Project: PRA-ROCR 10(5)
The purpose of this Amendment is to:

Amendment No. 0002
Project PRA-ROCR 10(5)
Rock Creek Park
Solicitation: DTFH71-16-R-00001

Project Name: Beach Drive from Rock Creek Parkway to Maryland State Line

AMENDMENT NO. 2 ◇1	PMIS NO.	NPS NO.	STATE	PROJECT	SHEET NO.
	044965	821 / 100425	DC	PRA-ROCR 10(5)	D44

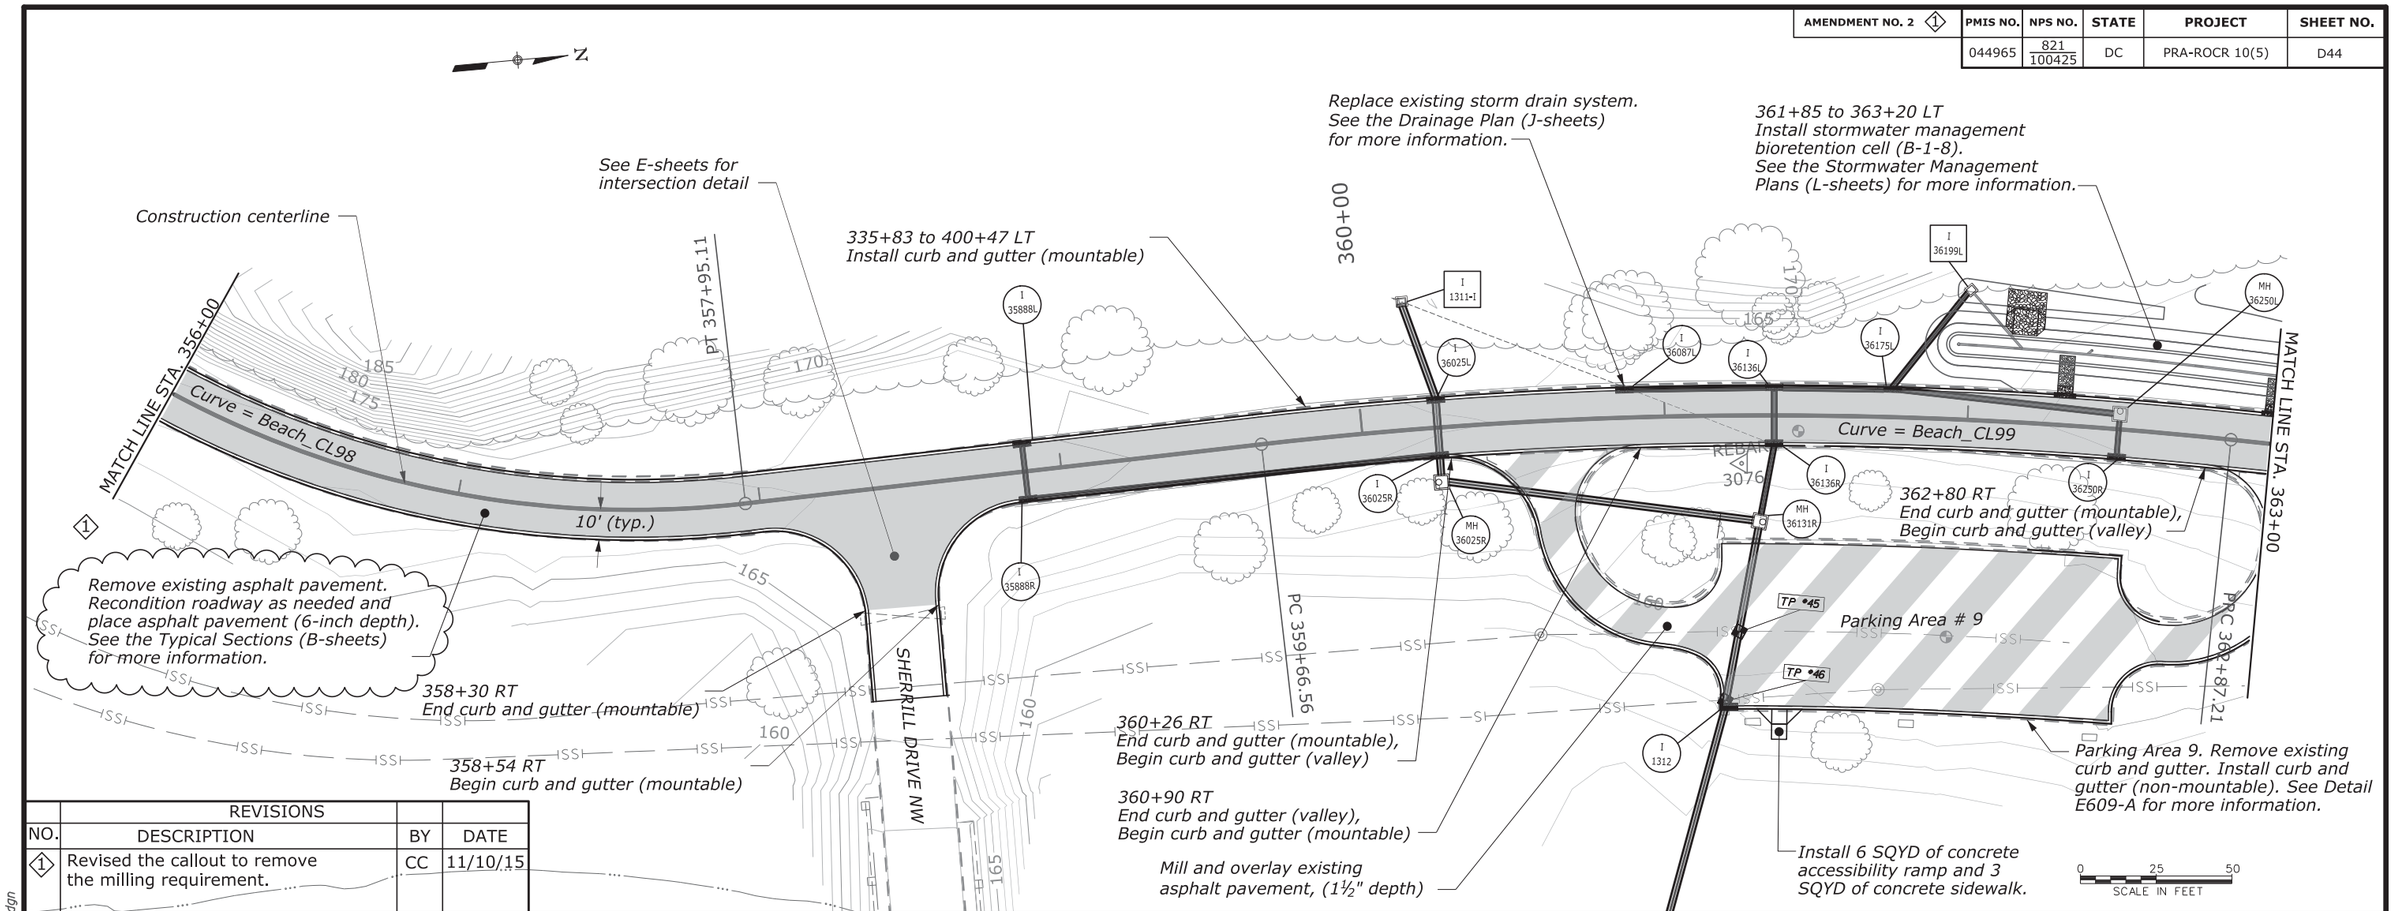
REVISIONS			
NO.	DESCRIPTION	BY	DATE
◇1	Revised the callout to remove the milling requirement.	CC	11/10/15

AMENDMENT NO. 2 ◇1	PMIS NO.	NPS NO.	STATE	PROJECT	SHEET NO.
	044965	821 / 100425	DC	PRA-ROCR 10(5)	D45

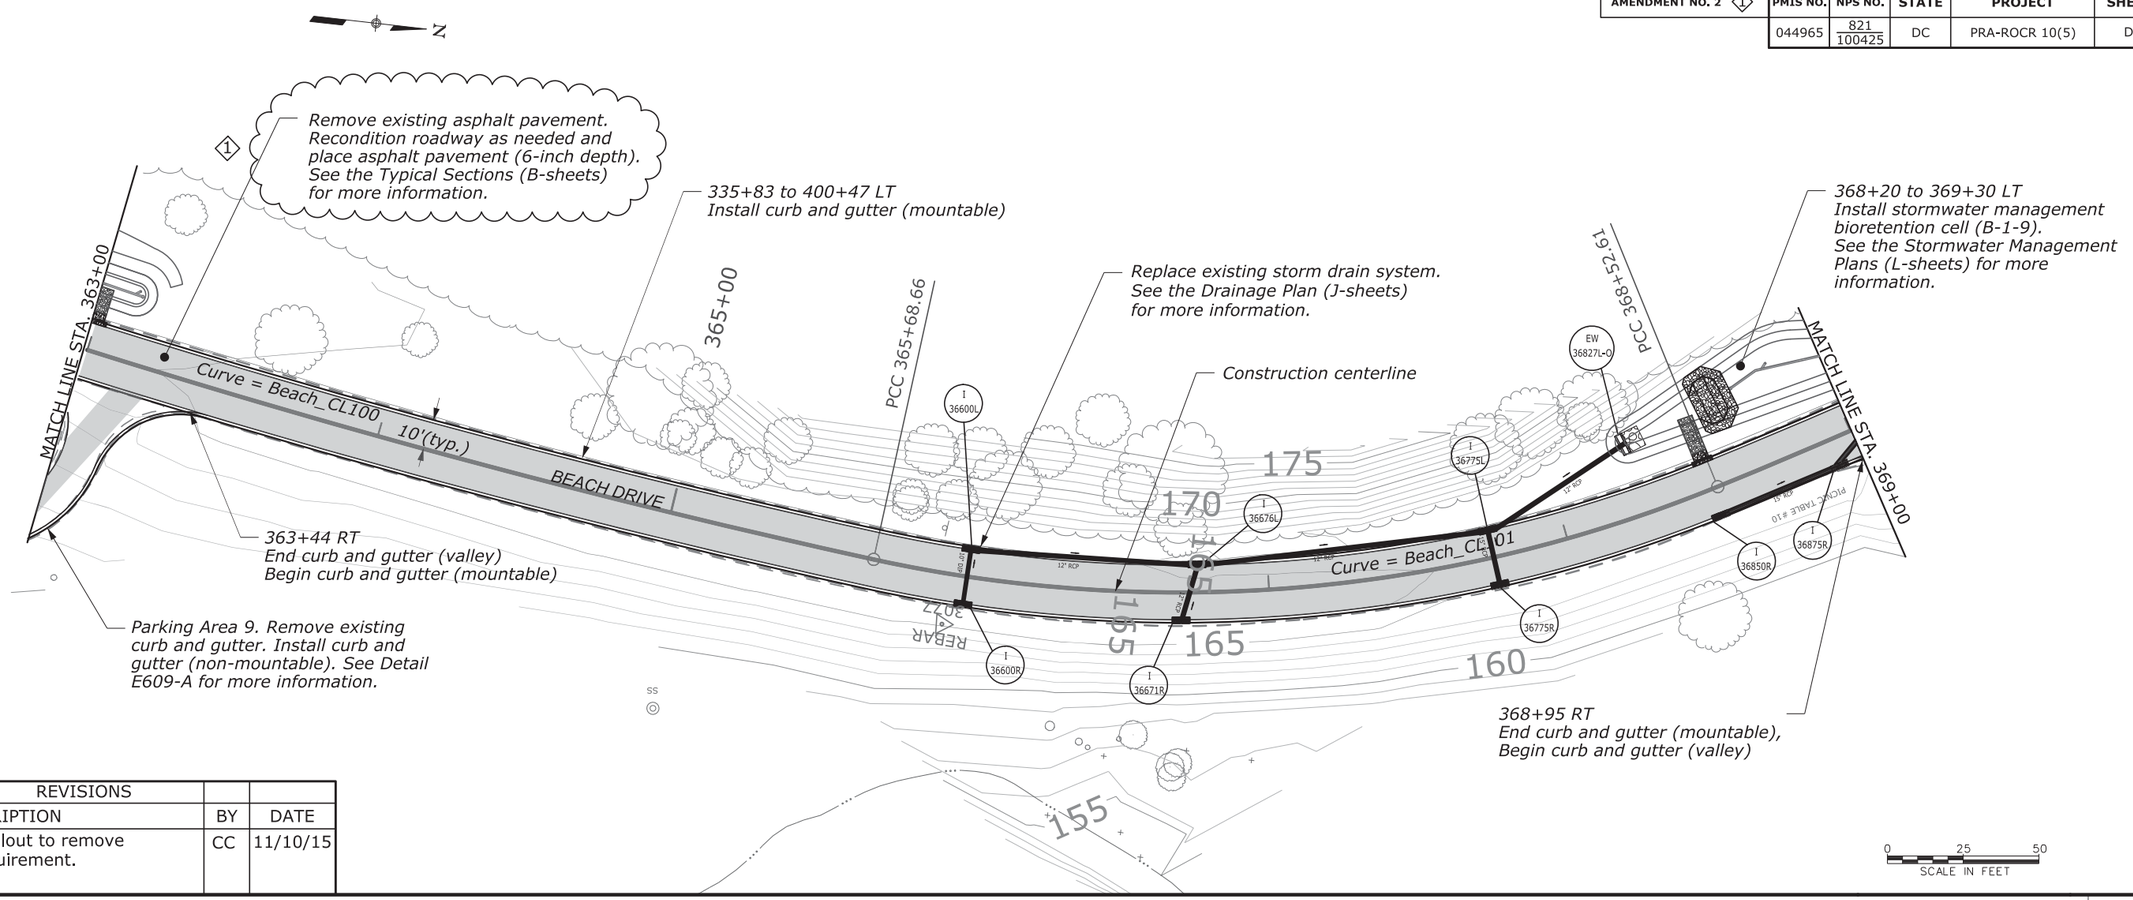
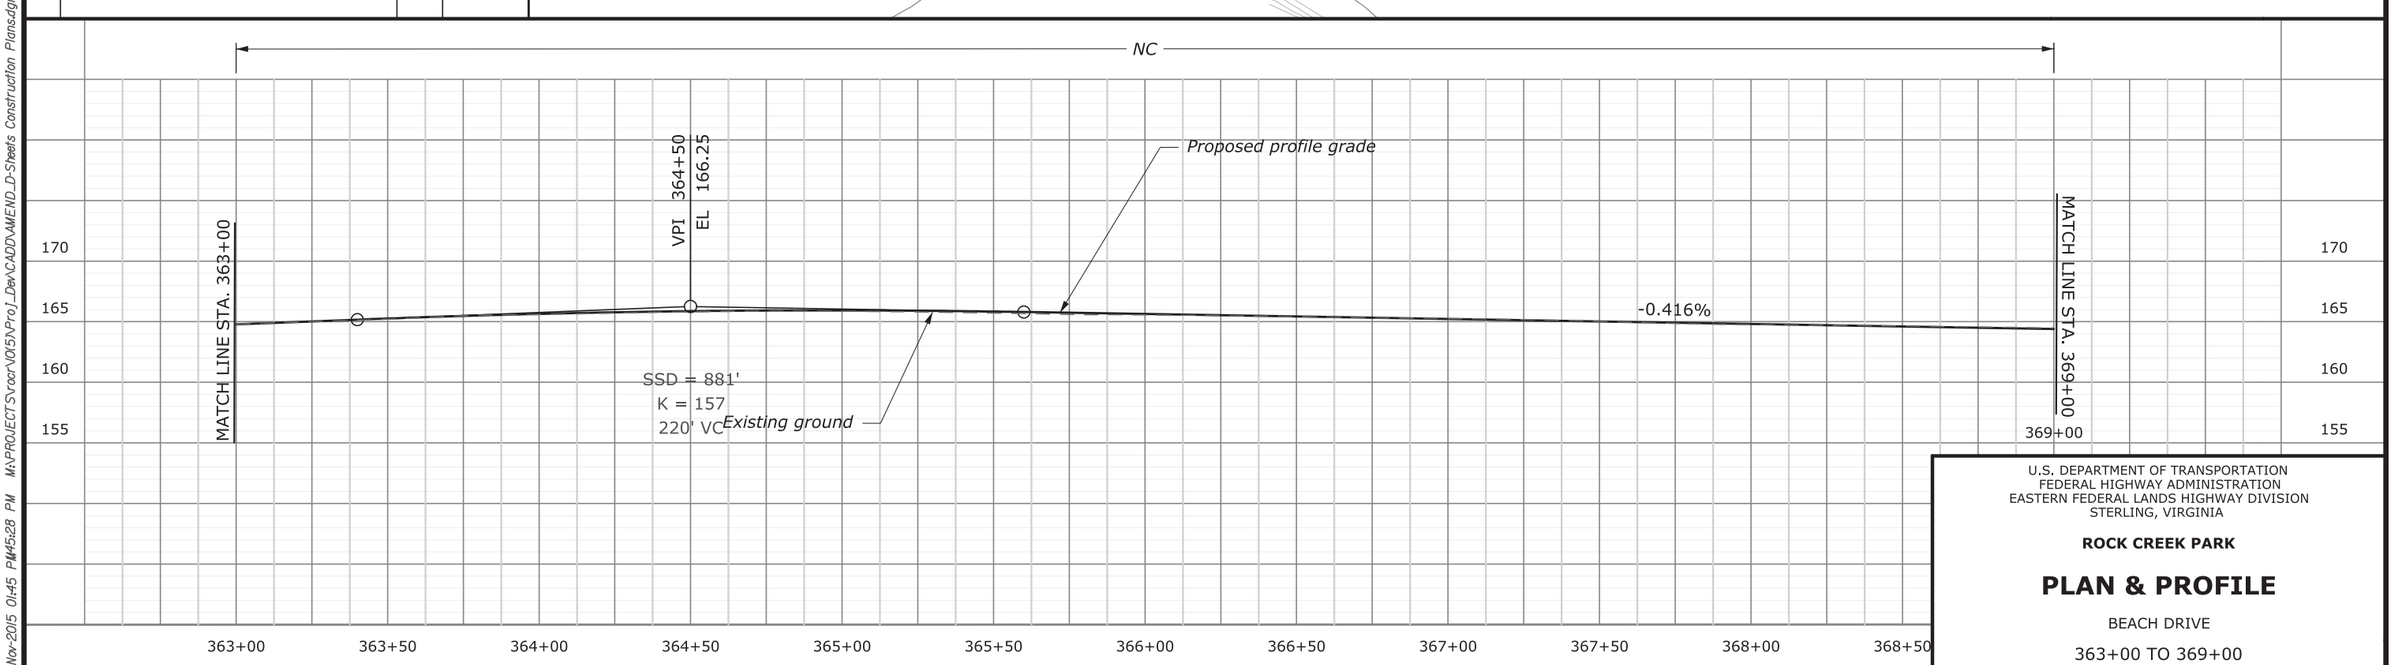
REVISIONS			
NO.	DESCRIPTION	BY	DATE
◇1	Revised the callout to remove the milling requirement.	CC	11/10/15

AMENDMENT NO. 2 ◇1	PMIS NO.	NPS NO.	STATE	PROJECT	SHEET NO.
	044965	821 / 100425	DC	PRA-ROCR 10(5)	D46

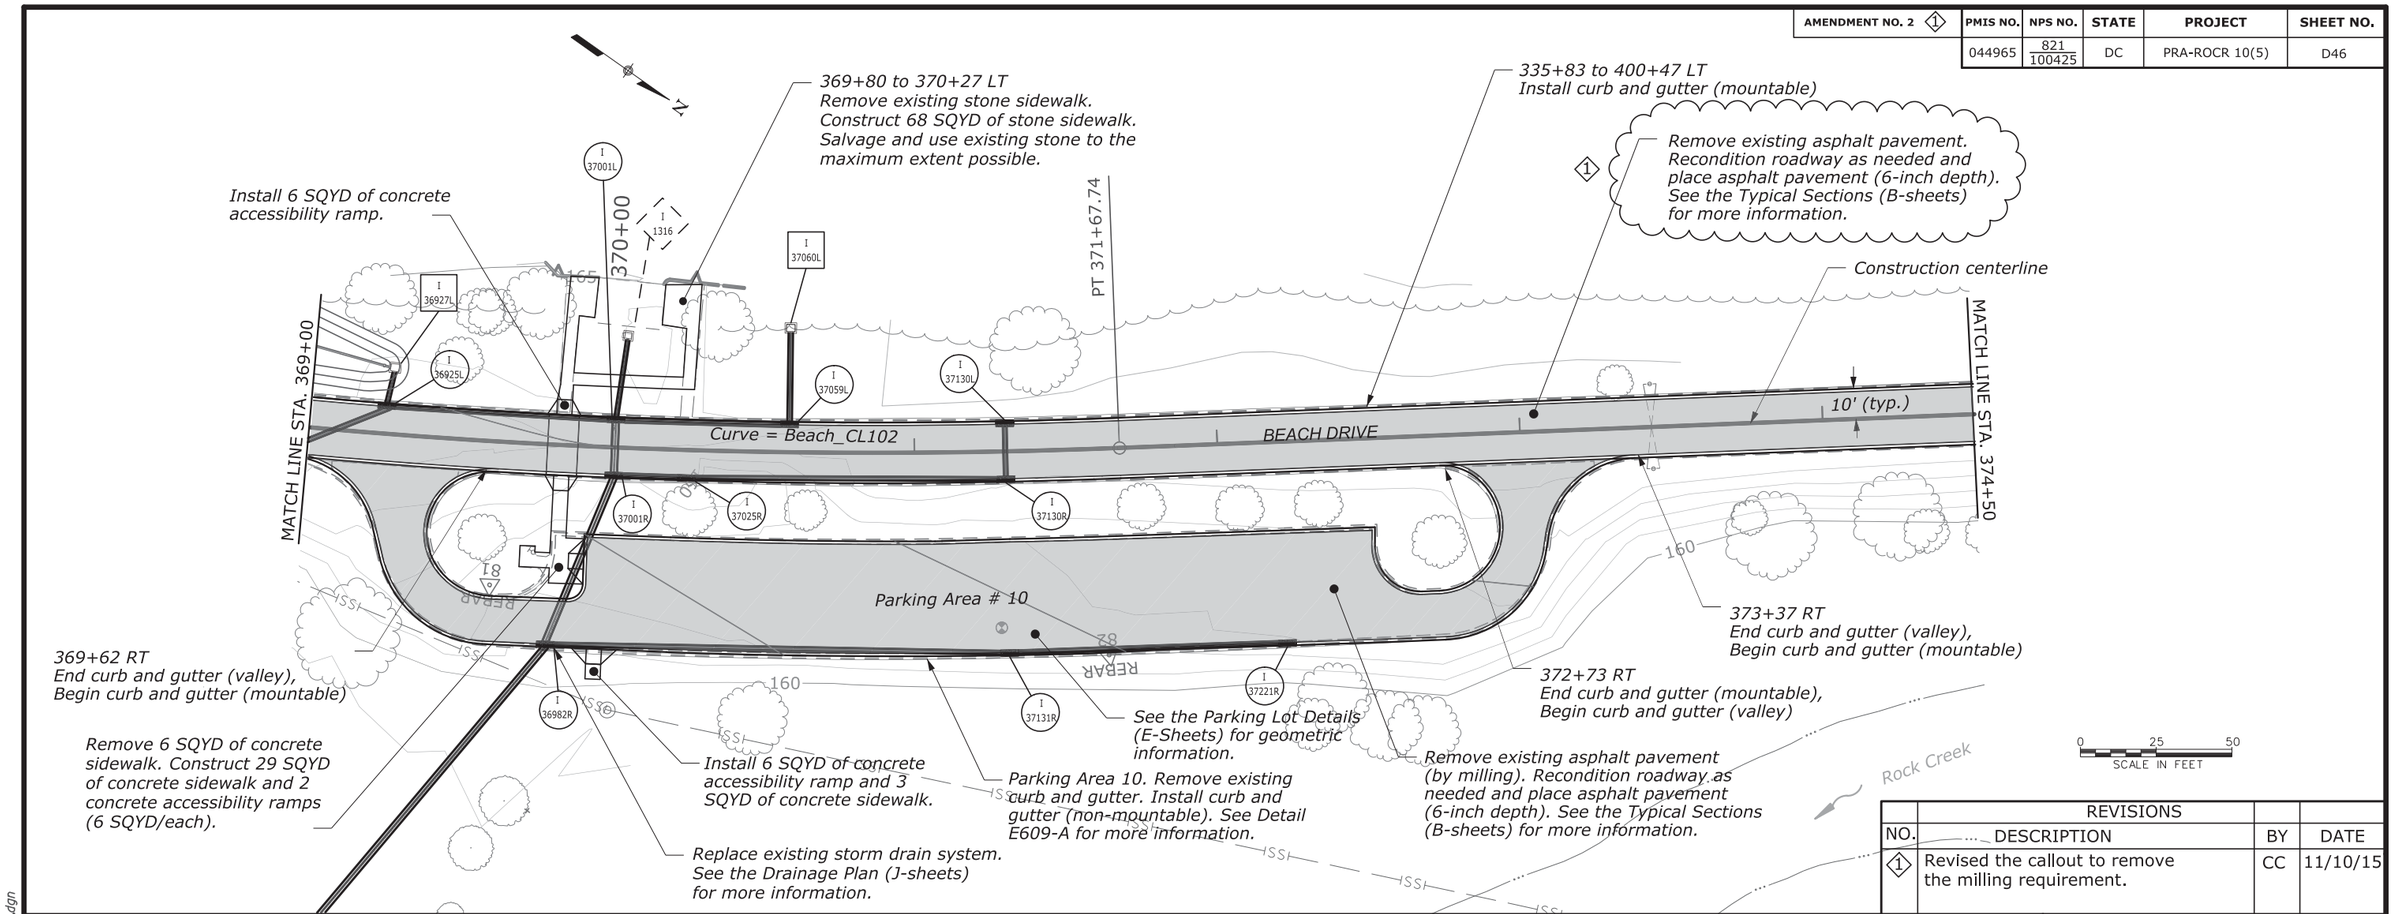
REVISIONS			
NO.	DESCRIPTION	BY	DATE
◇1	Revised the callout to remove the milling requirement.	CC	11/10/15

AMENDMENT NO. 2 ①	PMIS NO.	NPS NO.	STATE	PROJECT	SHEET NO.
	044965	821 / 100425	DC	PRA-ROCR 10(5)	D47

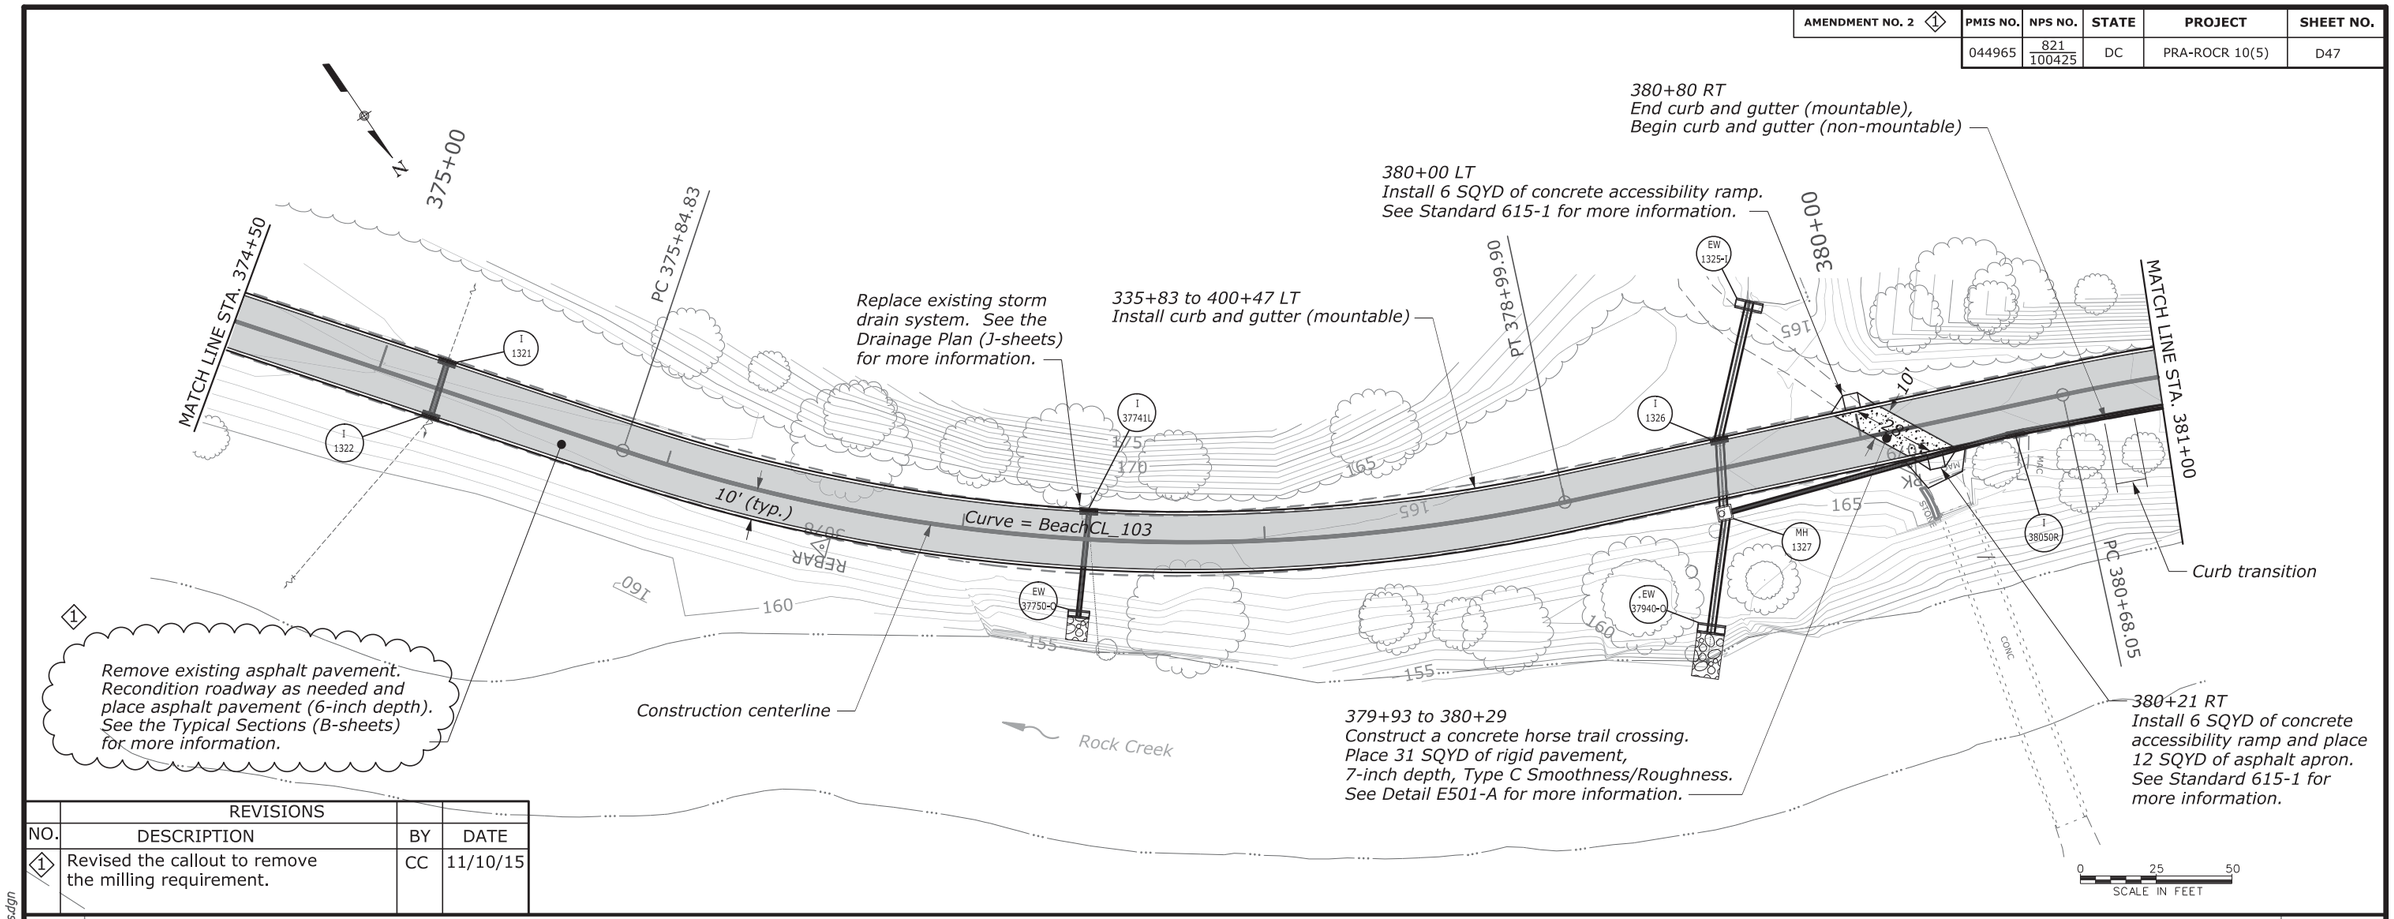
REVISIONS			
NO.	DESCRIPTION	BY	DATE
①	Revised the callout to remove the milling requirement.	CC	11/10/15
